Project	<b>IEEE 802.16 Broadband Wireless Access Working Group</b> < <a href="http://ieee802.org/16">http://ieee802.org/16</a> >
Title	<b>CR on SDD Section 17: Load Balancing between Femto and Macro BS</b>
Date Submitted	<b>2009-02-24</b>
Source(s)	Karthik Sundaresan, Sampath Rangarajan, <a href="mailto:karthiks@nec-labs.com">karthiks@nec-labs.com</a> Linghang Fan, Nader Zein, Tetsu Ikeda, Andreas Maeder, Amir Khojastepour, Mohammad Madihian  NEC
Re:	Change request to Project 802.16m System Description Document (SDD) (IEEE 802.16m-08/003r7)
Abstract	This contribution provides text addition to SDD to facilitate load balancing between femto, micro and macro BS in the network.
Purpose	For discussion and approval by IEEE 802.16m TG
Notice	<i>This document does not represent the agreed views of the IEEE 802.16 Working Group or any of its subgroups. It represents only the views of the participants listed in the "Source(s)" field above. It is offered as a basis for discussion. It is not binding on the contributor(s), who reserve(s) the right to add, amend or withdraw material contained herein.</i>

## Load Balancing between Femto and Macro BS

Figure 1a. Traffic concentration in femto cells.

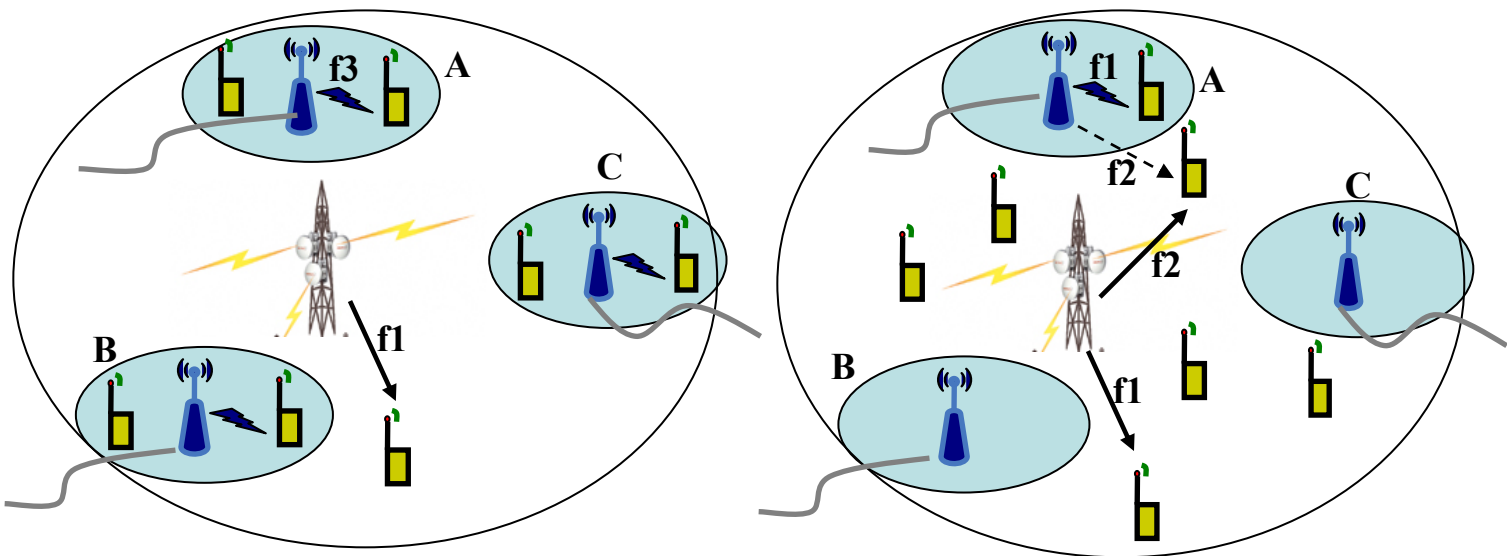
Current SDD text mentions that femto BS can coordinate with the macro BS or autonomously determine the resources to be used for its operation. Irrespective of which method is adopted, it does not currently provide provisions for load balancing between the femto and macro BS. Given the usage scenarios of femto cells in residences, enterprises, complexes, etc. it can be anticipated that the dynamics of traffic in these femto cells can vary significantly depending on the time of the day. For eg, one can expect more traffic from residential femto cells during the evenings. Given the large dynamic nature of load in these femto cells, it is very important for the service provider to coordinate the resources between macro and femto cells so that the resources are efficiently utilized contributing to better revenue. For eg. consider the scenario is Fig 1a and 1b. In Fig. 1a, the UE concentration is more in the femto cells compared to the macro, while in 1b it is the macro cell where traffic is concentrated. Using the same allocation of resources for both the scenarios will lead to poor utilization of resources and hence performance. For the scenario is 1a, more resources must be allocated towards the femto cells, while for 1b more resources must be allocated to the macro cell.

To address this load balancing scenario, it is important for some coordinating entity (say macro BS) to

periodically collect some traffic performance metric (load, utility, etc.) from the macro and femto BS to decide on the amount of resources that can be allocated to the macro BS and the femto BS. How the macro and femto BS decide to use these resources is not within the scope of this document. However, being able to periodically collect traffic metrics from them will help efficiently balance the load between them and adapt it to varying network dynamics. The periodicity (semi-static nature) of such information collection could also be implementation dependent.

### 17.12 Load Management and Balancing

It is important to efficiently balance the load between the macro and femto BS to optimize capacity and QoS. To achieve this, some traffic performance metric (load, utility, etc.) should be periodically collected from the macro and femto BS to decide on the amount of resources that will be used by the macro, micro and the femto BS. How the macro and femto BS decide to use these resources in a distributed manner is not within the scope of this document. However, being able to periodically collect traffic metrics from them will help efficiently adapt and balance the load between them and adapt it to varying network dynamics. The periodicity (semi-static nature) of such information collection could also be implementation dependent.
